**MIDWEST CITY  
PLANNING COMMISSION**

**July 7, 2020 – 7:00 p.m.**

1. (PC-2045) Public hearing with discussion and consideration of ordinance to redistrict from R-6, Single Family Residential to R-HD, High Density Residential, for the property described as a part of the SW/4 of Section 12, T-11-N, R-2-W, located at 2500 South Douglas Blvd.

2. (PC-2046) Public hearing with discussion and consideration of an ordinance redistricting from Planned Unit Development (PUD) to Amended Planned Unit Development (PUD), for the property described as a part of the Lots 7-10 of the Thomas Acres Addition addressed as 9070 NE 13<sup>th</sup> Street.

SHEET NUMBER  
**C1.0**  
 19-056

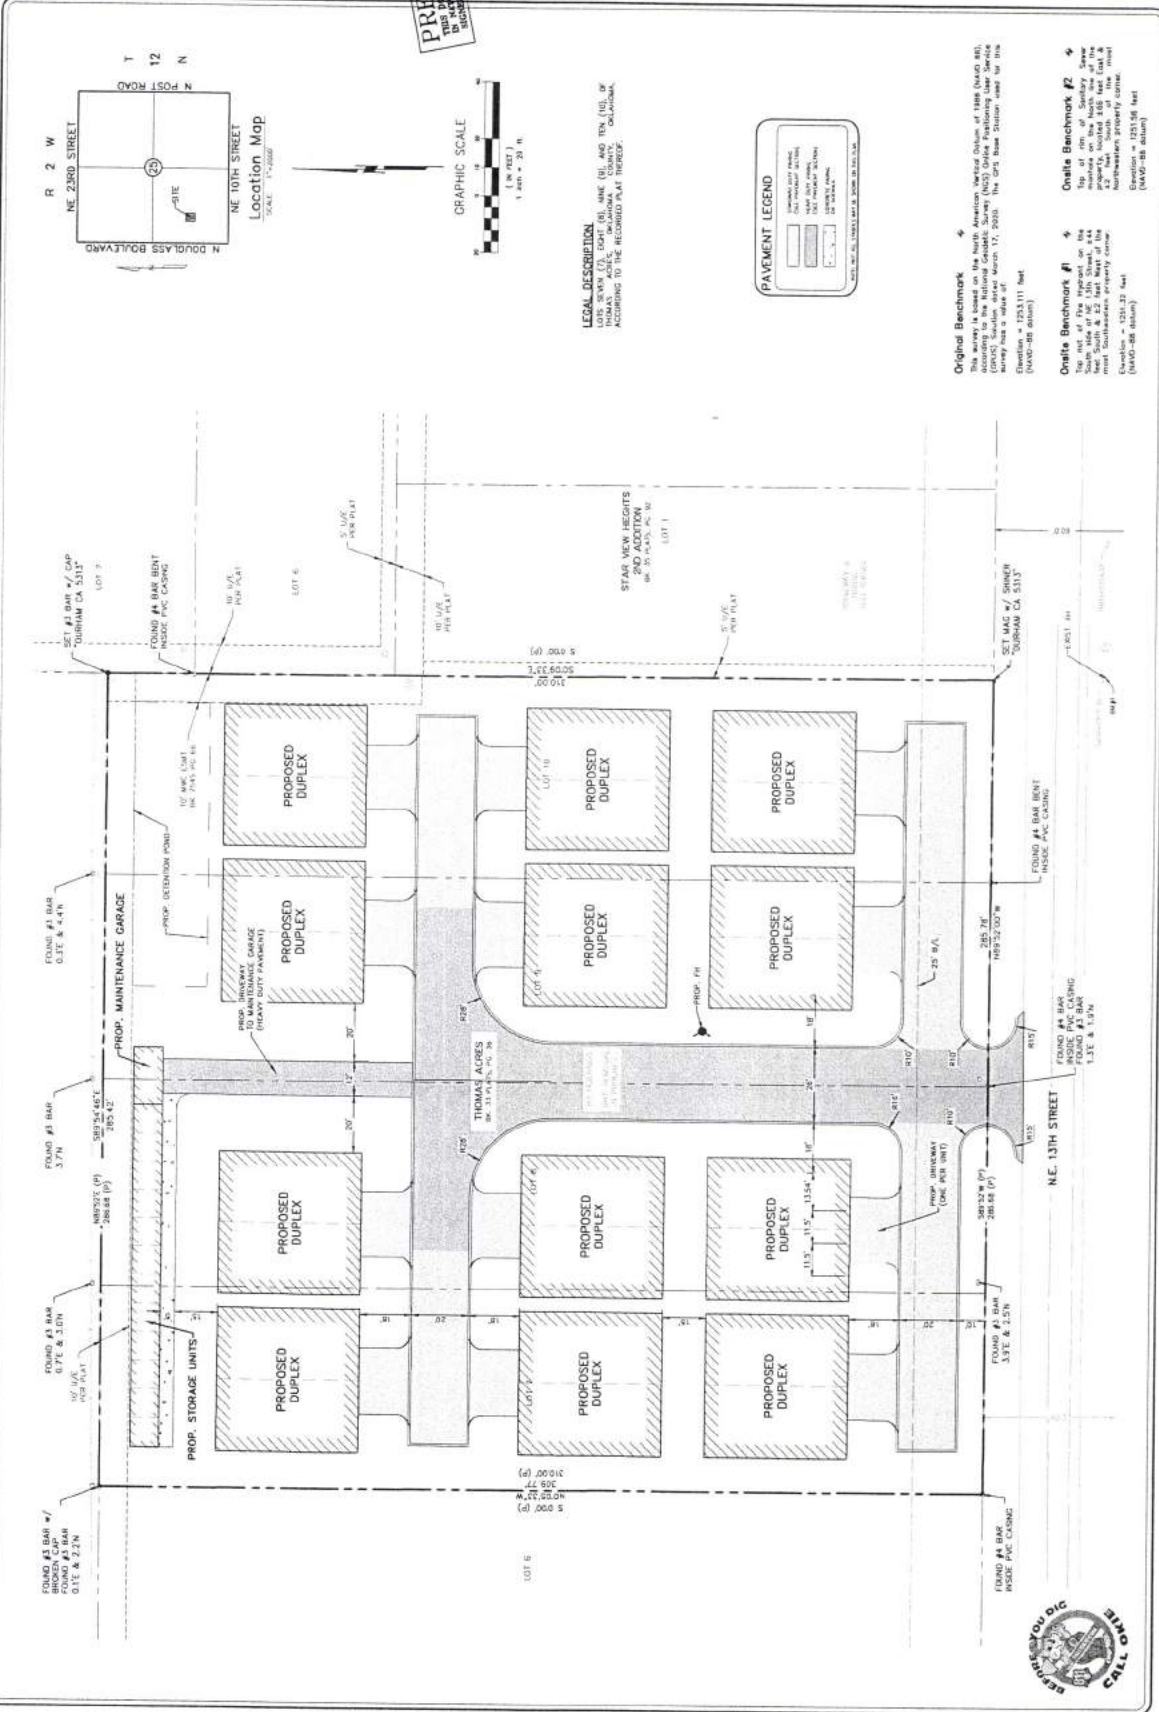
The private drive providing access to each of the residential structures will be required to be built to Midwest City standards but will remain private. The Master Development Plan approved with the previous PUD was approved with rollover curbs. The site plan submitted with this application does not show rollover curbs.

Looking south along east boundary. Note fall towards north and West

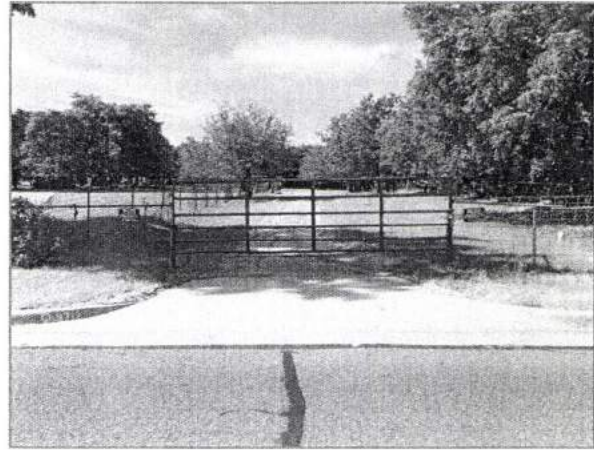
The proposed development is gently sloped to the northwest. Existing property drains via sheet flow to the west and to the north where is picked up by the curbing along E Main Street. Drainage to the proposed development generally is as follows:

- A developed storm sewer system runs along the south side of E Main Street.
  - On the northeast corner of the property, there is an open paved ditch junction which accepts water as an inlet off E Main Street and a pipe running off the eastern property.
  - The outflow of this paved junction then runs west ~640' via piping to an existing drainage box and then ultimately north to Soldier Creek Tributary 4.
- Drainage which does not fall into the above system sheet flows across the proposed development and then the neighboring property to the west; ultimately making its way to curbing along E Main Street. The curbing then takes the water to the same existing drainage box as the above pipe system.

Looking south along east boundary. Note fall towards north and west

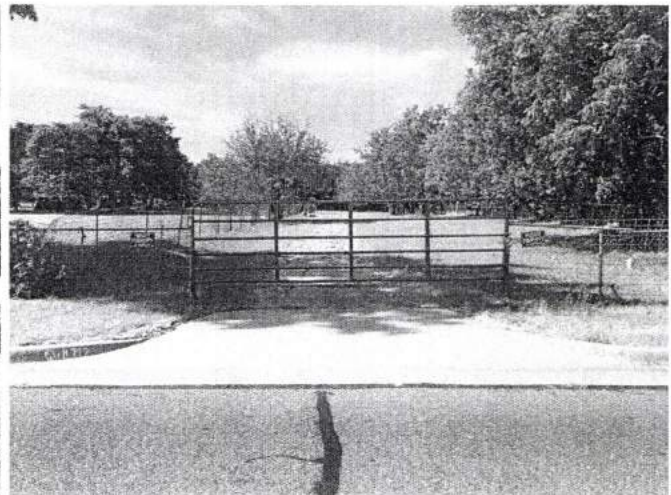
The proposed development is gently sloped to the northwest. Existing property drains via sheet flow to the west and to the north where is picked up by the curbing along E Main Street. Drainage to the proposed development generally is as follows:
